CNL-15-128

Sequoyah Nuclear Plant, Units 1 and 2
Facility Operating License Nos. DPR-77 and DPR-79
NRC Docket Nos. 50-327 and 50-328

Subject: **Sequoyah Nuclear Plants, Units 1 and 2 Technical Specifications
Conversion to NUREG-1431, Rev. 4.0 (SQN-TS-11-10) - Supplement 2**

**Sequoyah Nuclear Plant, Units 1 and 2 Technical Specifications Conversion to
NUREG-1431, Rev. 4.0 (SQN-TS-11-10) - Revision 1**

Figure 4.3.1.2-1
New Fuel Storage Rack Loading Pattern

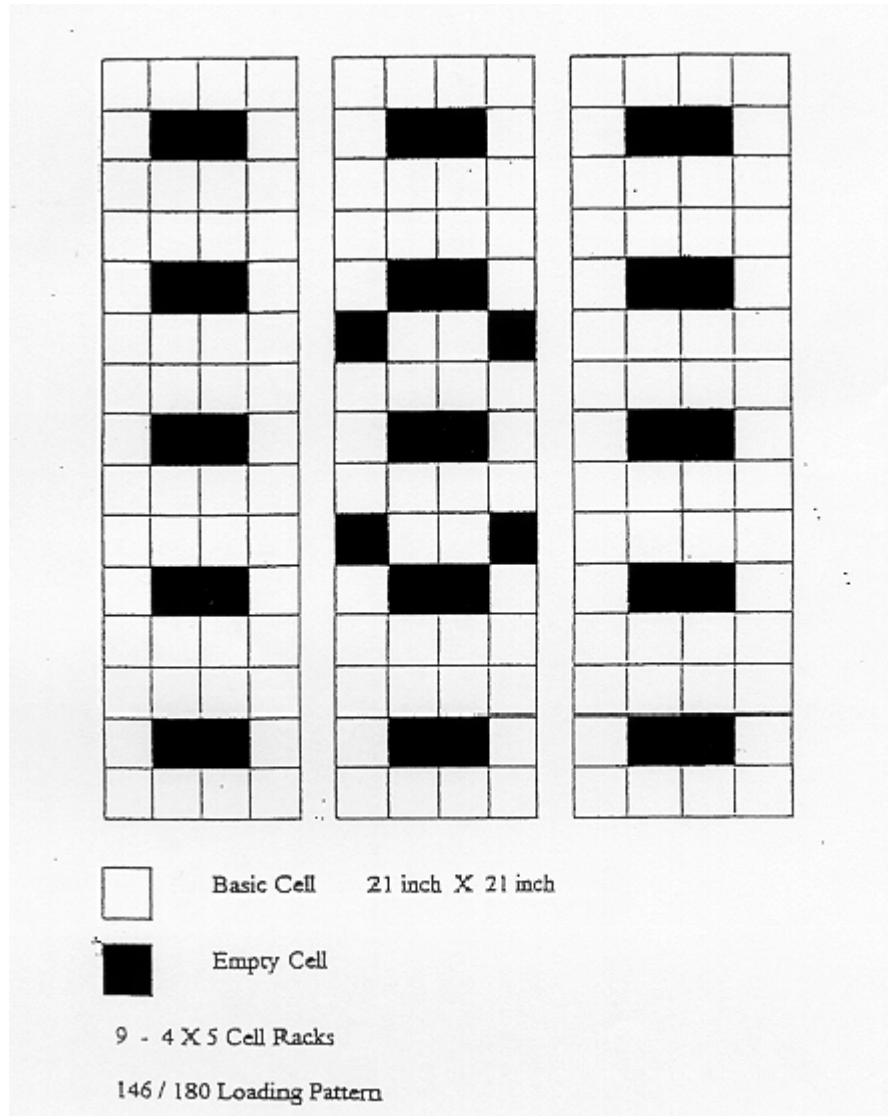
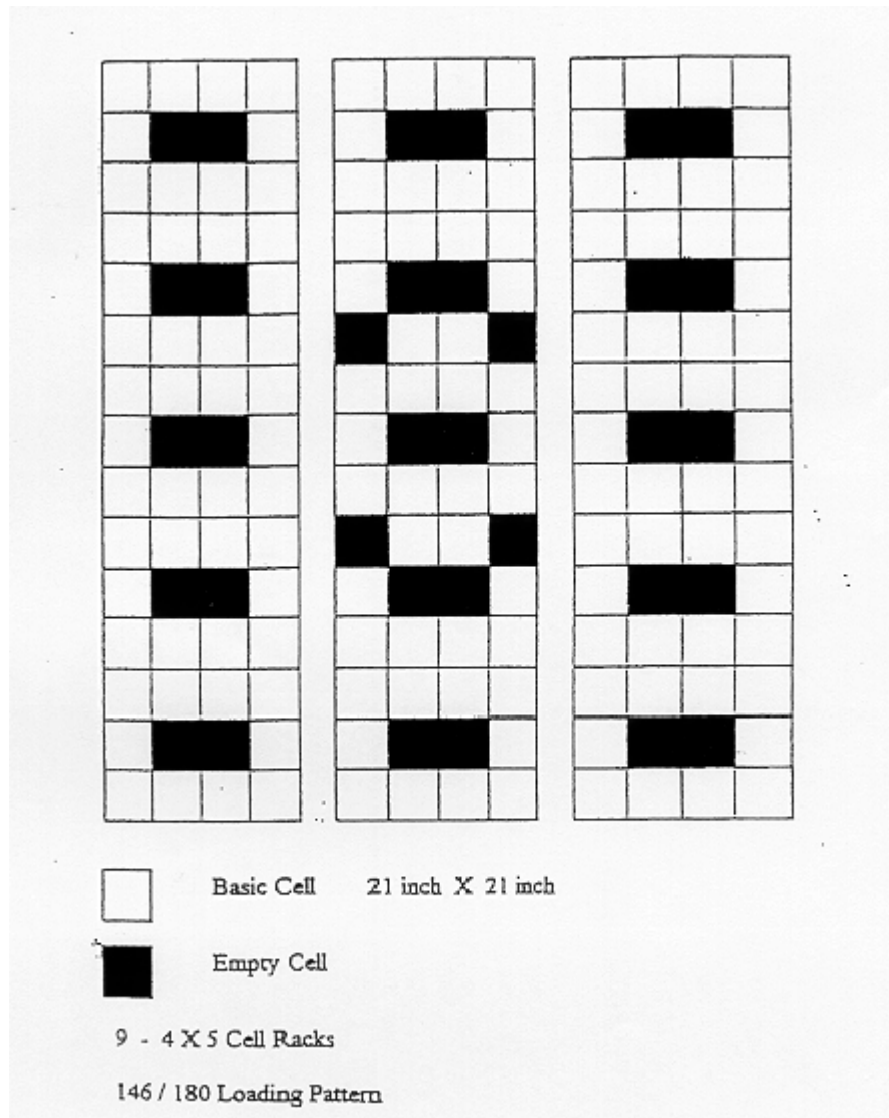
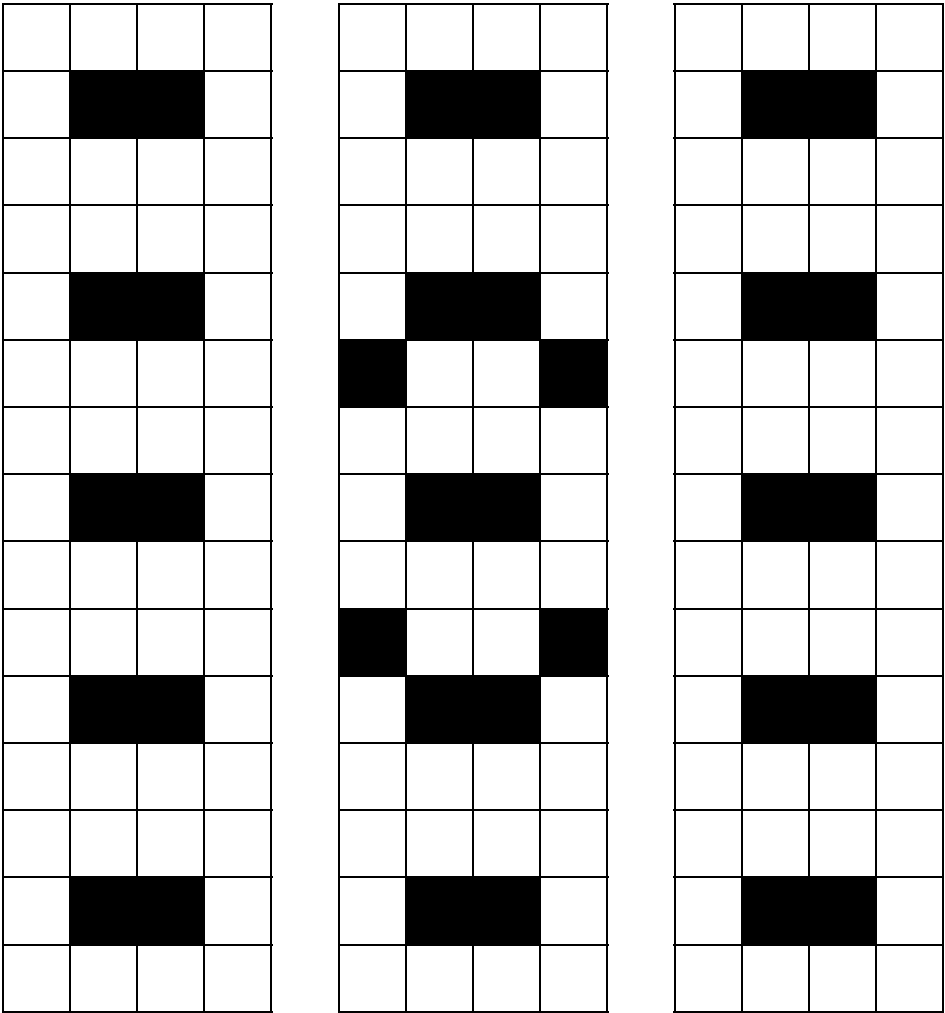
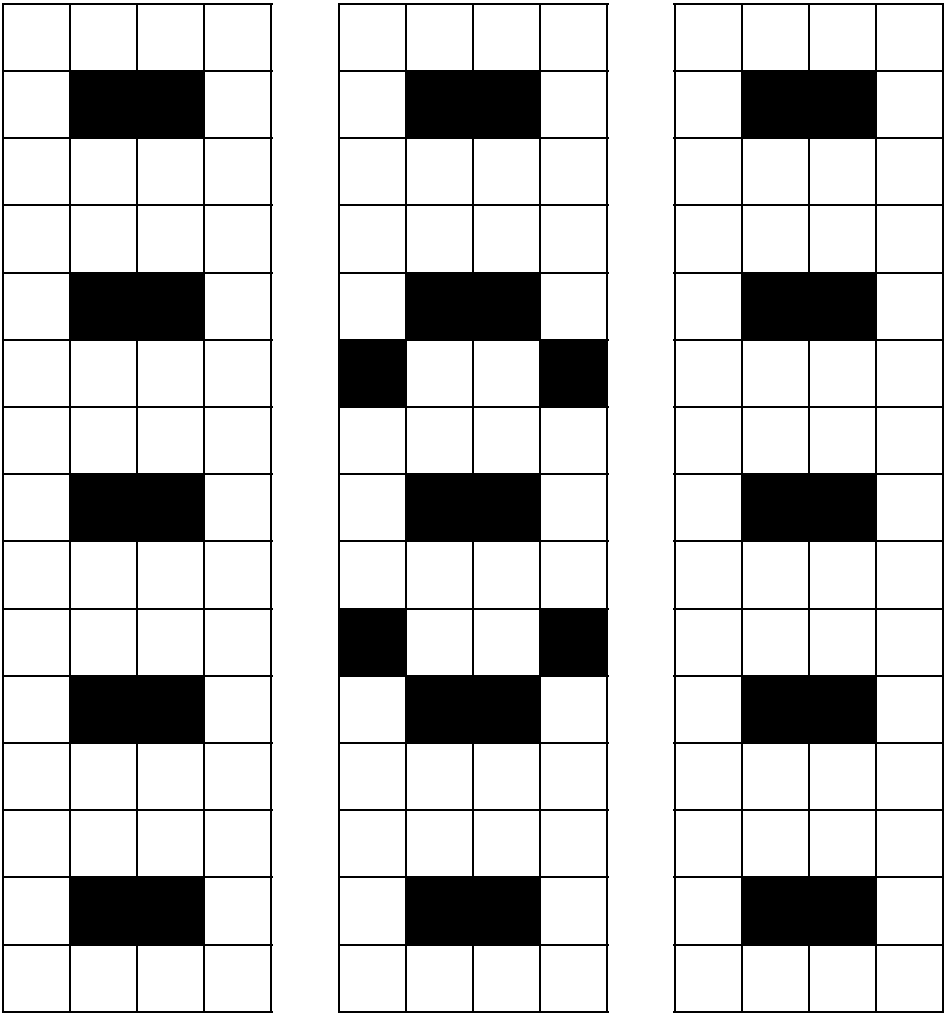
- 4.3.1.2.a — 5.6.1.2 The new fuel pit storage racks are designed for fuel enriched to 5.0 weight percent U-235 and shall be maintained with the arrangement of 146 storage locations shown in Figure 5.6-4. The cells shown
- 4.3.1.2.d — as empty cells in Figure 5.6-4 shall have physical barriers installed to ensure that inadvertent loading of fuel assemblies into these locations does not occur. This configuration ensures k_{eff} will remain less than or
- 4.3.1.2.b — equal to 0.95 when flooded with unborated water and less than or equal to 0.98 under optimum moderation
- 4.3.1.2.c — conditions.

5.6.1.2 The new fuel pit storage racks are designed for fuel enriched to 5.0 weight percent U-235 and shall be maintained with the arrangement of 146 storage locations shown in Figure 5.6-4. The cells shown as empty cells in Figure 5.6-4 shall have physical barriers installed to ensure that inadvertent loading of fuel assemblies into these locations does not occur. This configuration ensures k_{eff} will remain less than or equal to 0.95 when flooded with unborated water and less than or equal to 0.98 under optimum moderation conditions.

The arrangement of 146 storage locations shown in Figure 4.3.1.2-1. The cells shown as empty cells in Figure 4.3.1.2-1 shall have physical barriers installed to ensure that inadvertent loading of fuel assemblies into these locations does not occur.
